PUR-1649
ADDENDUM NO. 2

REQUEST FOR PROPOSALS
REGARDING QUALIFICATIONS & EXPERIENCE/
AND PRICE PROPOSALS

DEPARTMENT OF SOLID WASTE
ARCHEOLOGICAL SERVICES AT WASHINGTON COUNTY
40-WEST LANDFILL

SHEET TITLE
**ADMIN/MAINTENANCE
FACILITIES SITE PLAN**
PROJECT TITLE
**LUND TRACT
SANITARY LANDFILL**

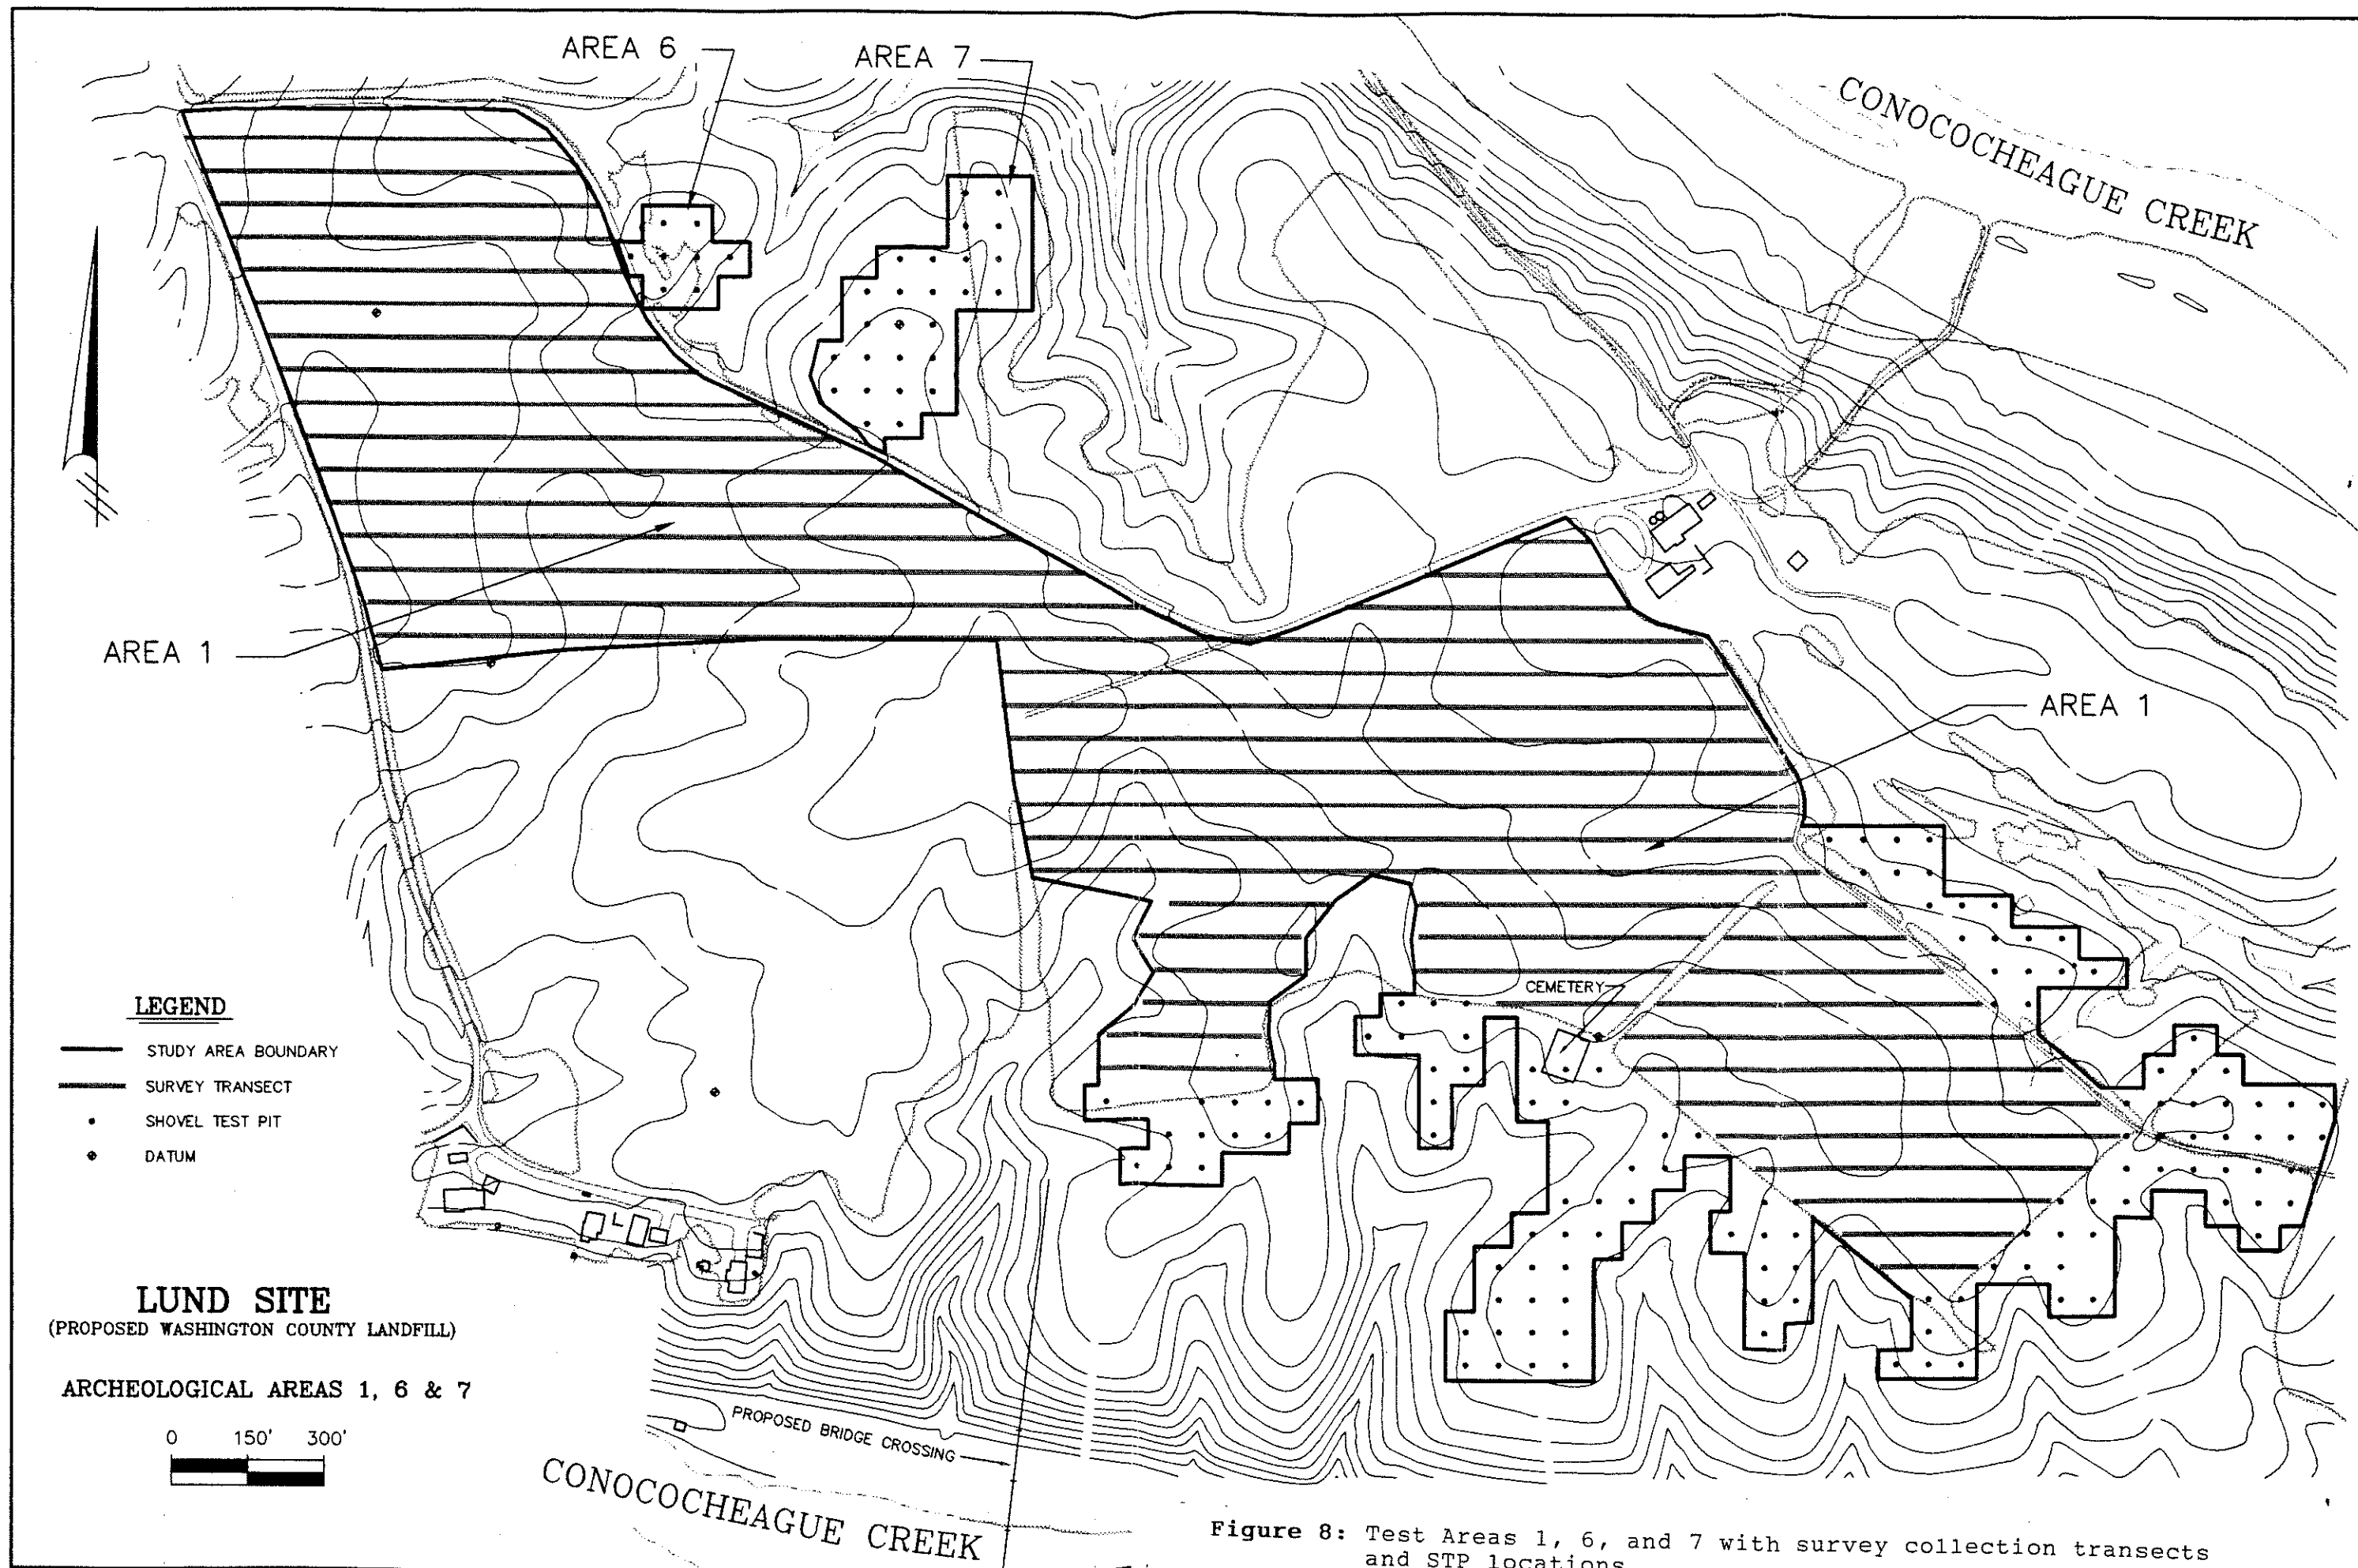
ITEM NO. 1: *Inquiry:* Would it be possible to obtain a copy of the original construction plans for the area of the landfill near to the gravestone discovery, showing depth of grading and limits of disturbance?

Response: The drawing is attached; also, a page that was inadvertently omitted from Phase I and II Archeological Investigation of the proposed Washington County Lund Landfill Site, Conococheague, Washington County, Maryland; is attached.
